**Rye House
Hollands Lane
Henfield
West Sussex
BN5 9QY**

PLEASE reference this letter on the website as: 'RYE HOUSE 3 - FLOOD & DRAINAGE'

Re: Sandgate Nursery, West End Lane, Henfield, West Sussex BN5 9RD
Reference DC/23/0189
Outline application for erection of a continuing care retirement community of up to 72 units of accommodation (Use Class C2) and up to 10 starter homes (Use Class C3) with associated community facilities including medical centre and on-site laundry and catering facilities, with access, infrastructure, open space, landscaping and associated works (all matters reserved except for access).

FLOOD RISK & DRAINAGE

Fig 1 Extract from the applicant's Flood Risk Assessment, Drainage Strategy and Water Neutrality Report - appendix F

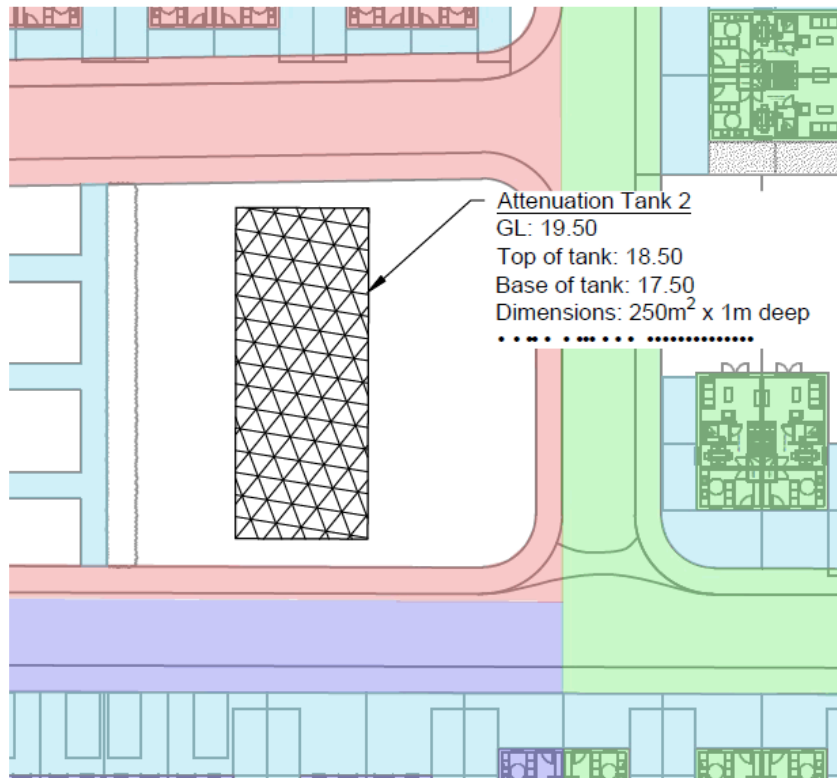
Attenuation tank 2

Due to the slope of the land, we fail to understand how this tank, in the middle of the site and located roughly at the highest point, would be suitably located to accept surface water run-off.

Fig 2 - further report detail - southwest corner

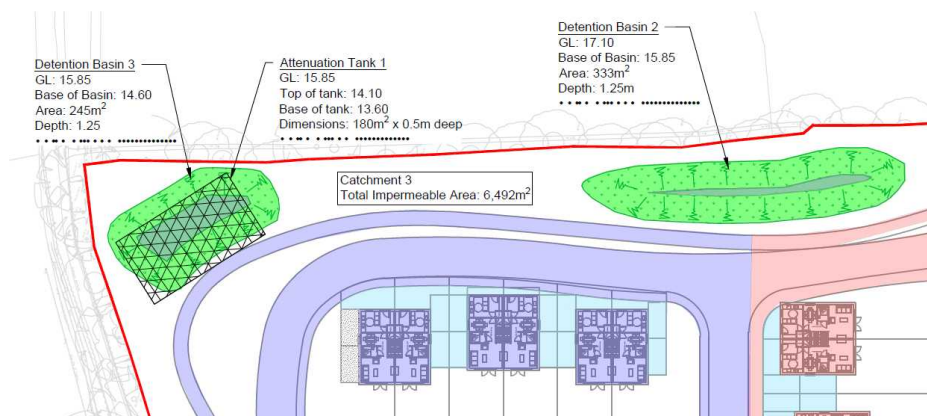
Southwest corner

The land slopes generally to the south and southwest, so we assume this tank is proposed to accept the much of the water run-off in this corner, which is considerable, as evinced by the images in **Figs 3 & 4** below. As we said above, there is no coherent explanation of how this tank is expected to drain. The photos clearly show the volume of standing water. Our contention is that the SuDS proposal here will never work – it's not enough.

Fig 5 - further report detail - southeast corner

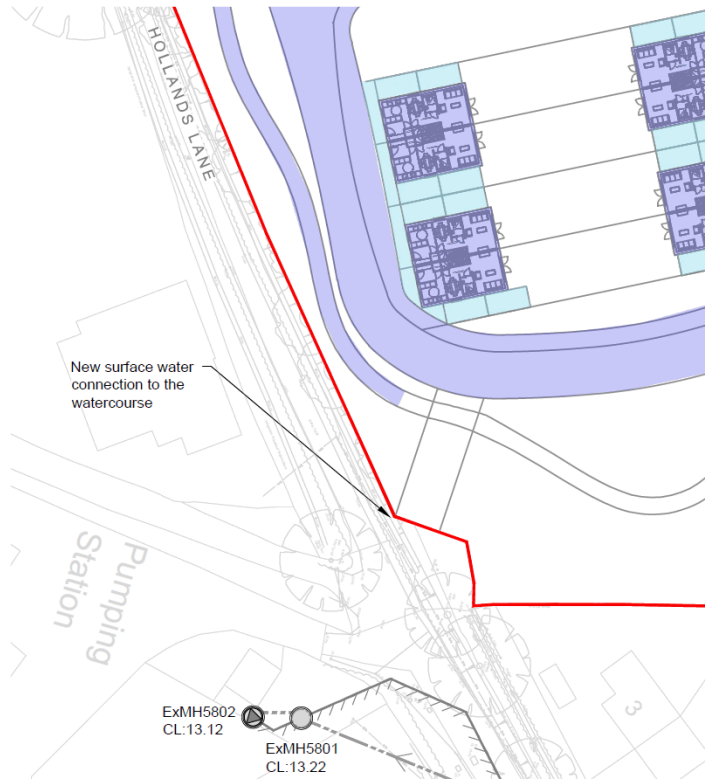
Fig 5 above proposes ‘a new surface connection to the watercourse’. There is no natural watercourse but there is the ditch shown above.
